PBHE's Response to Technical Safety BC's Report on

The 3 Fatalities due to Ammonia Release at Fernie Memorial Arena - Oct. 17, 2017

Date: August 28, 2018

Figure 3: Schematic of the Fernie Memorial Arena curling refrigeration system. Numbers identified correspond to the items and descriptions in the Table 1 below.

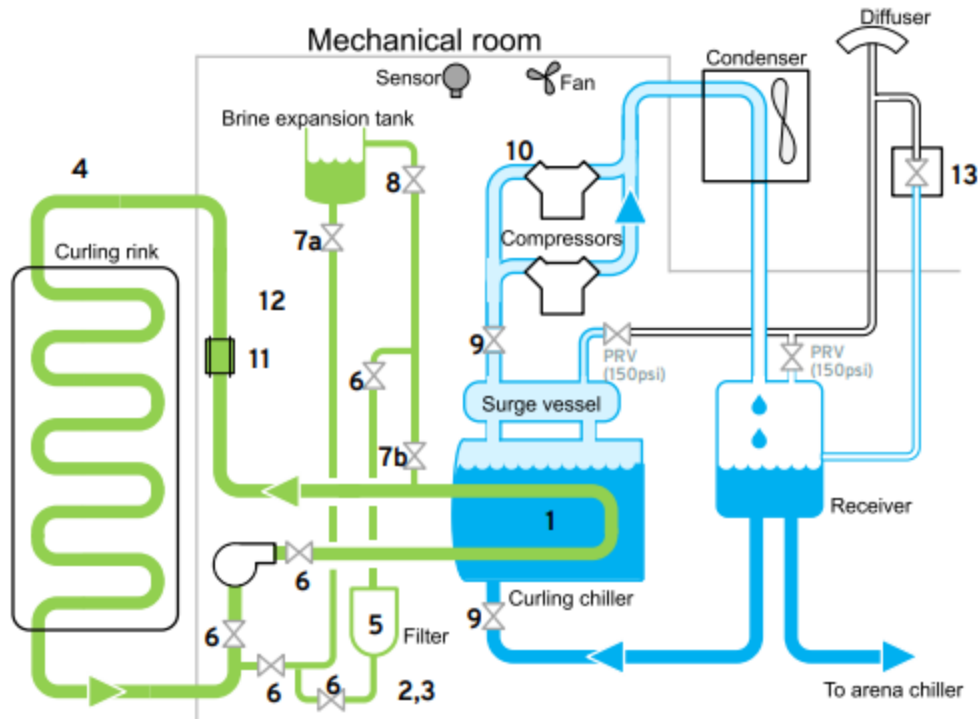
2. Given the schematic shown in Figure 3, there are multiple ways that the brine system could be pressurized by the ammonia system. (Technical Safety BC. *"Investigation Report Ammonia Release – Fernie Memorial Arena."* 2018, Page 9) It is not uncommon to have a major rupture in a heat exchanger and this condition should have been anticipated.

Photo C3-5: Close up of upper tubes from return end of chiller upon opening in January 2018.

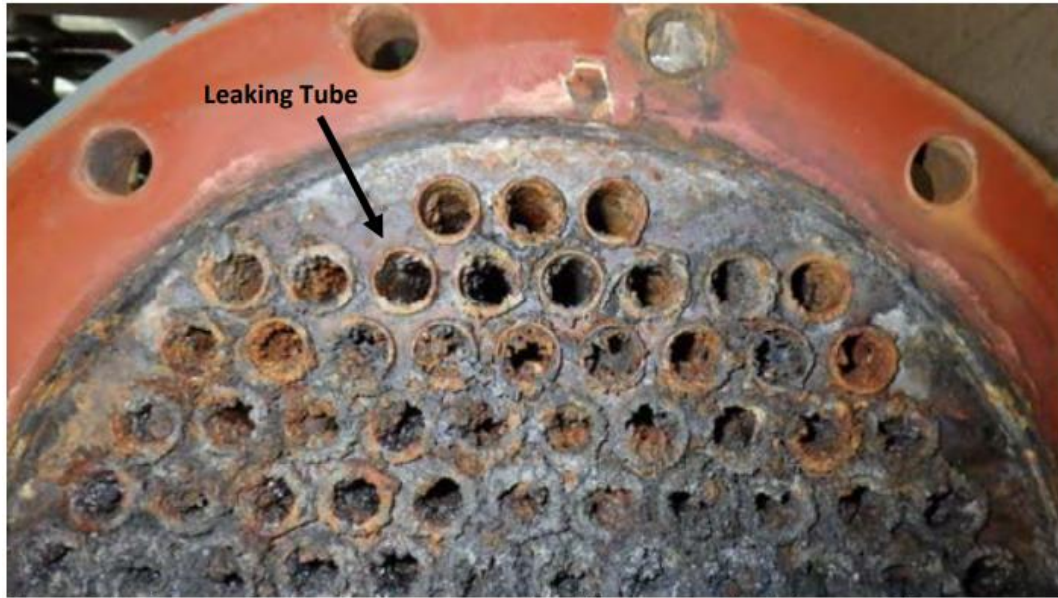
4. Calcium chloride brine, tube welds and time (31 yrs.) was the cause of the tube leak. Technical Safety BC's recommendations should identify the corrosive power of calcium chloride brine and therefore be considered when setting chiller life span. A glycol solution is less corrosive to chiller tubes but is less efficient than a calcium chloride brine solution. With the end covers removed, it is apparent that all of the tubes were in severe condition (shown in photo C3-4 and C3-5 below).

Figure 14: The dilution rate of the ammonia in the machine room for a 4 kg instantaneous release of ammonia, assuming a volume averaged concentration.

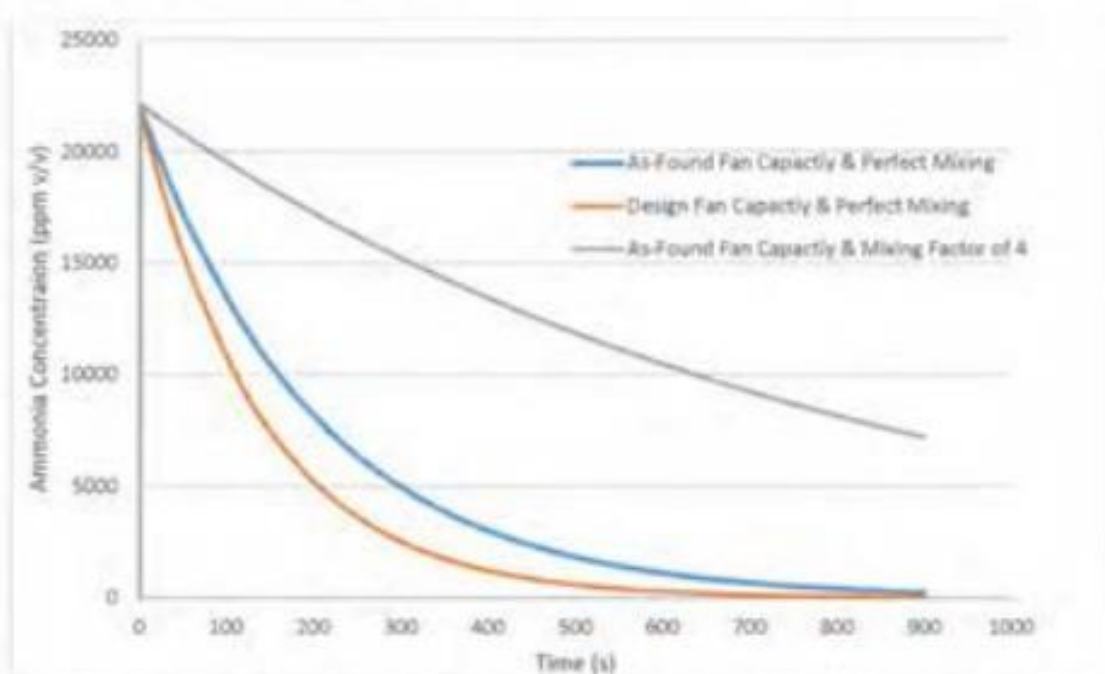
9. The ammonia concentration in the room reached over 20,000 ppm and likely remained above 15,000 ppm for at least 5 minutes. If the ventilation system was functioning with the designed air flow and perfect mixing, the ammonia concentration should have dissipated to below 4,000ppm after 5 minutes. This is shown in the graph below (the resolution quality of the original document is unreadable). (Technical Safety BC. *"Investigation Report Ammonia Release – Fernie Memorial Arena - Appendices."* 2018, Page 30)

This is still significantly above the life threatening ammonia levels. The ventilation system was yet another piece of equipment that was not functioning properly.
